DEVELOPMENT REVIEW BOARD MEETING
JANUARY 9, 2023
6:30 PM

2. **Resolution No. 410. ESS Parking Lot Expansion Project.** The applicant is requesting approval of a Stage 2 Final Plan Modification and Site Design Review for a parking lot expansion for the ESS building located at 26440 SW Parkway Avenue.

**DEVELOPMENT REVIEW BOARD
RESOLUTION NO. 410**

Exhibit A1
Staff Report
Wilsonville Planning Division
ESS Parking Lot Expansion

SHEET NO.
C4.00

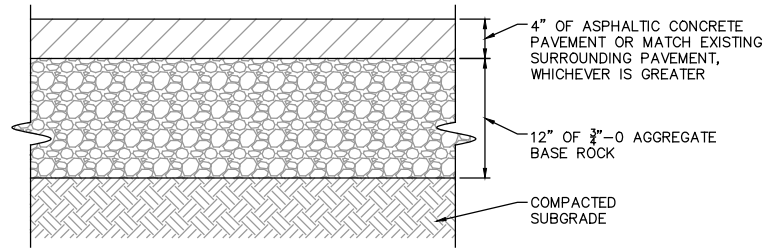
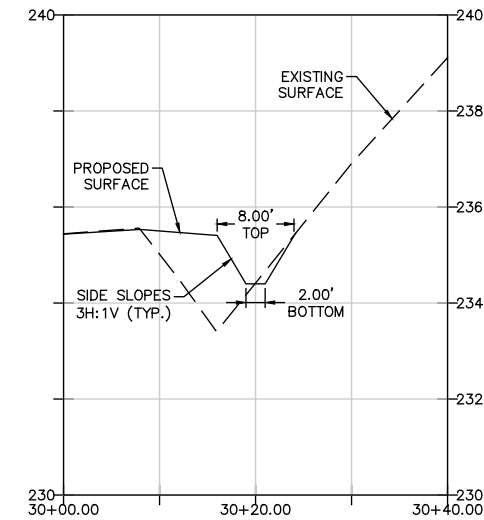
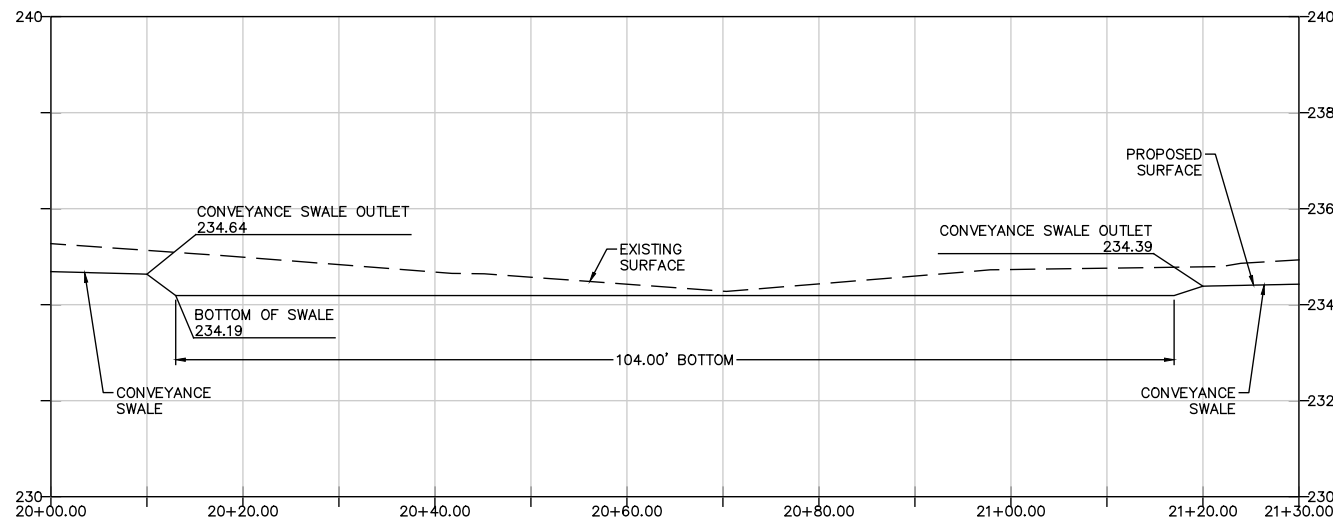
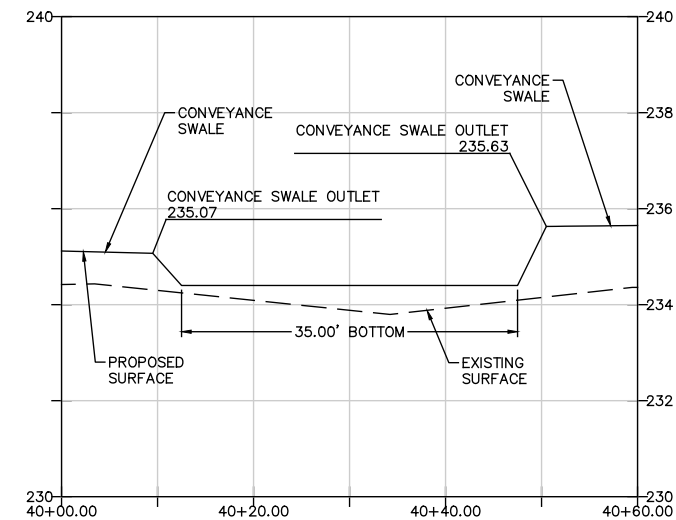
A35. As shown on Sheets C4.00 (Exhibit B2), materials required to meet landscaping standards are provided. The screening and buffering of the parking area from the Public Right of Way will be accomplished through a combination of the proposed landscaping and dense existing vegetation along the northern property line. A condition of approval will require the applicant to provide a complete list of shrub and groundcover species to be planted in the storm water swales prior to issuance of construction permits.
